# TCEQ PERMIT COVER SHEET

TPDES PERMIT NO. WQ0014488003  
[For TCEQ office use only - EPA I.D.  
No. TX0136778]

City of Dripping Springs

Re: City of Dripping Springs  
New TCEQ Permit Application  
TPDES Permit Number WQ0014488003  
Response to July 11, 2016 Comment E-mail  
CMA Job Number 1695-001

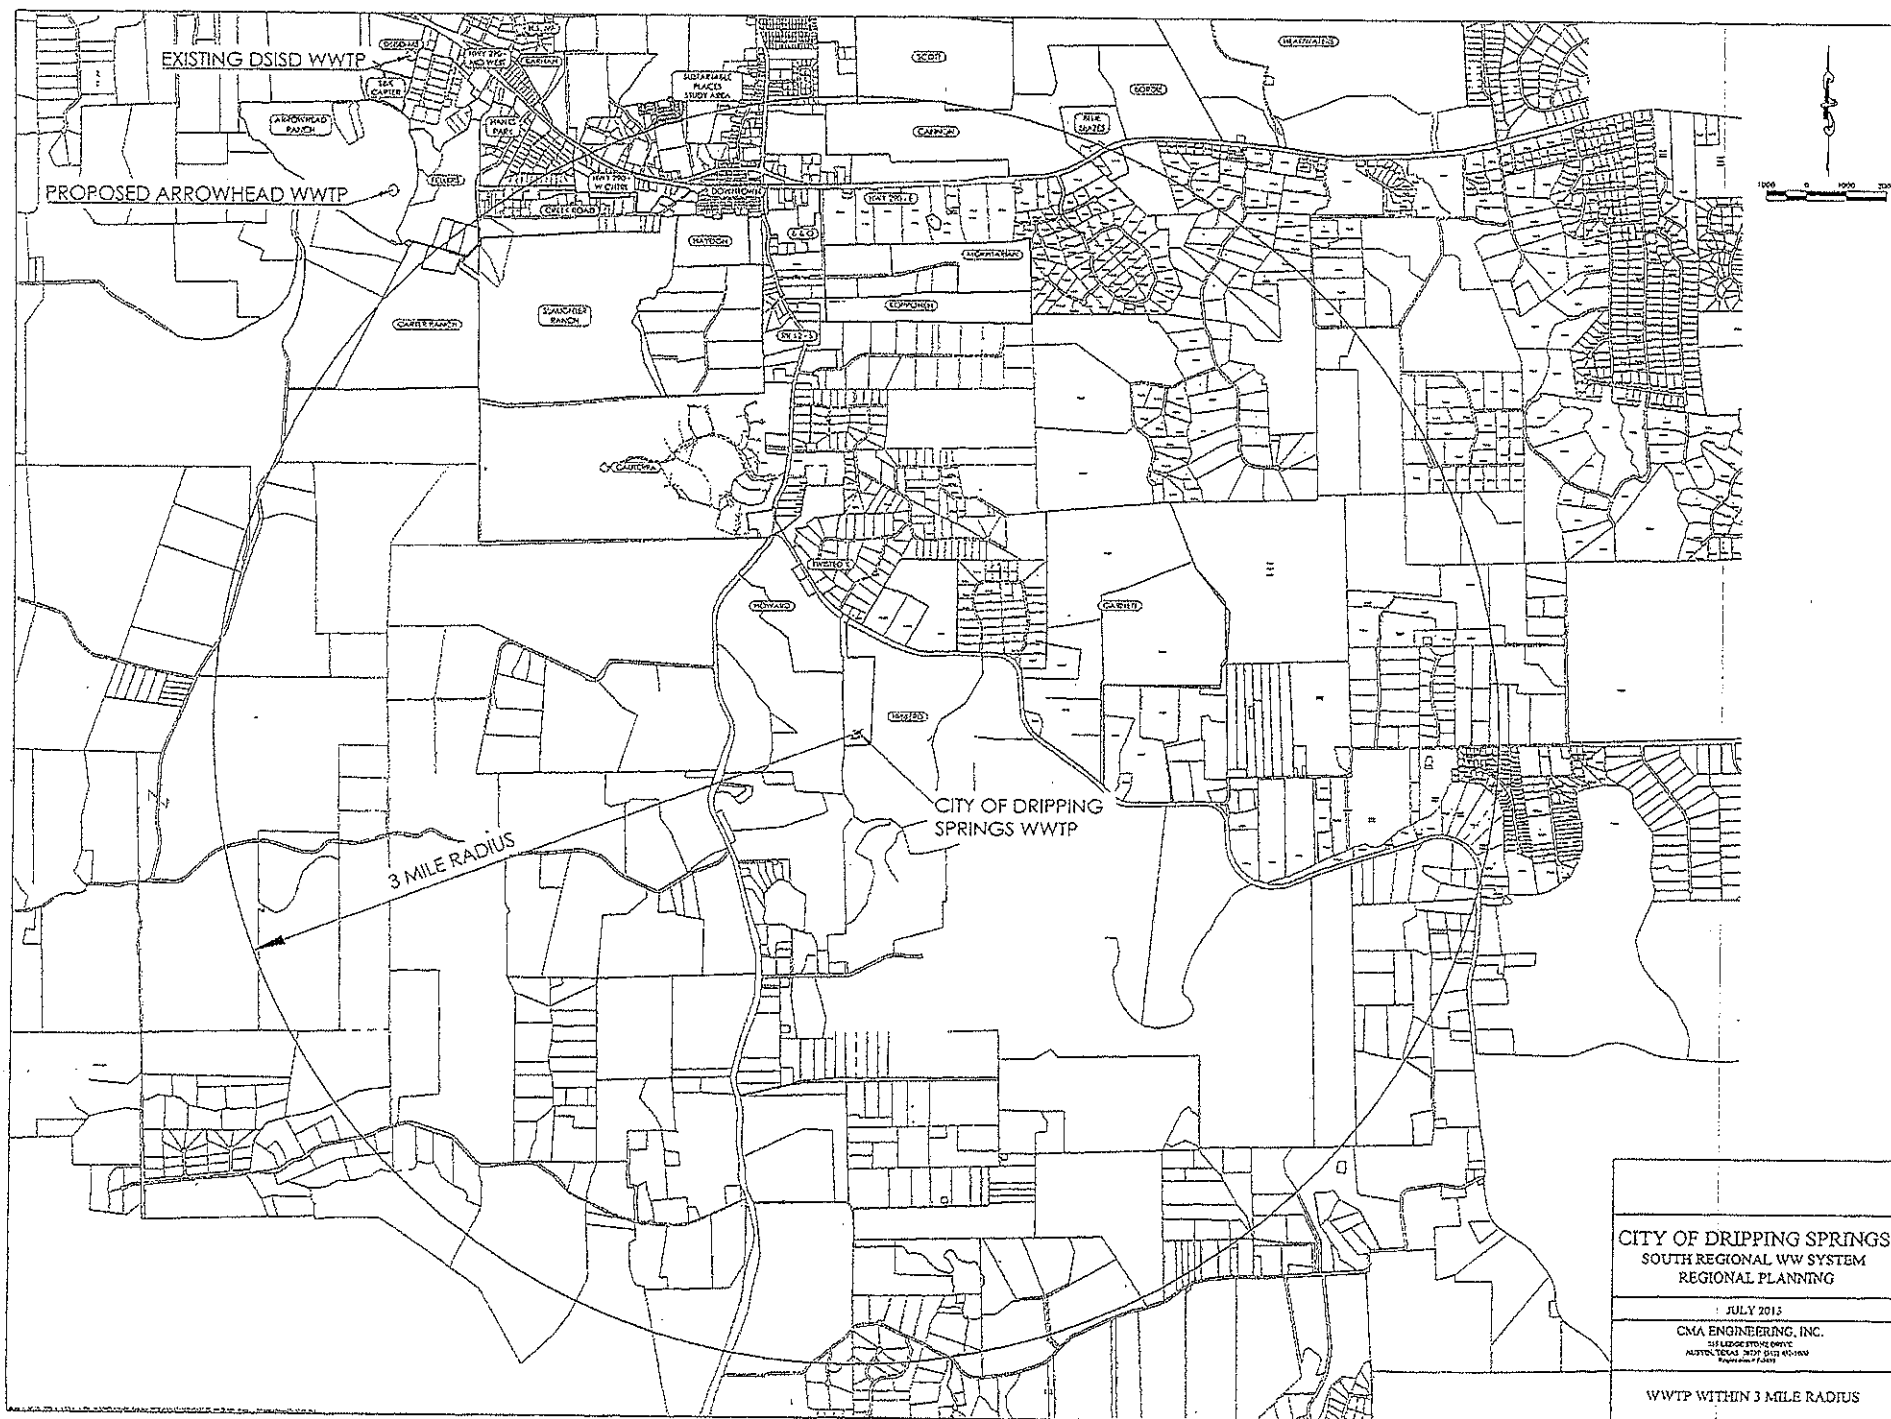
*Comment 1: Item 1(c)(3) on pages 21 and 22 of the technical report 1.1 (see Attachment 1): The applicant identified permitted wastewater facilities and/or collection systems within a three-mile radius of the proposed facility. To complete the response to this item, we need for you to please provide a list of these facilities and the reason why there is no need to contact these facilities.*

*Comment 2: Treatment Process Description (see Attachment 2): The application refers to the use of the existing effluent tank (cap 333,000 gal) for the Interim I and II phases with an additional effluent storage for the Final phase. Is there an estimate of the additional storage capacity for the Final phase?*

Response 1: Attached is an exhibit illustrating a three-mile radius around the proposed facility. There are no wastewater facilities within the three mile radius. Below are the closest two wastewater facilities, and an explanation of why there is no need to contact these facilities.

Response 2: The existing 333,000 gallon effluent holding tank is in service as part of the City's current land application permit number WQ0014488001. It is the intention of the City to use this tank for effluent storage as for future 30 TAC 210 Reuse. As mentioned in the Carollo Technical Memorandum No. 1, further evaluation will be required to evaluate if additional storage will be required.
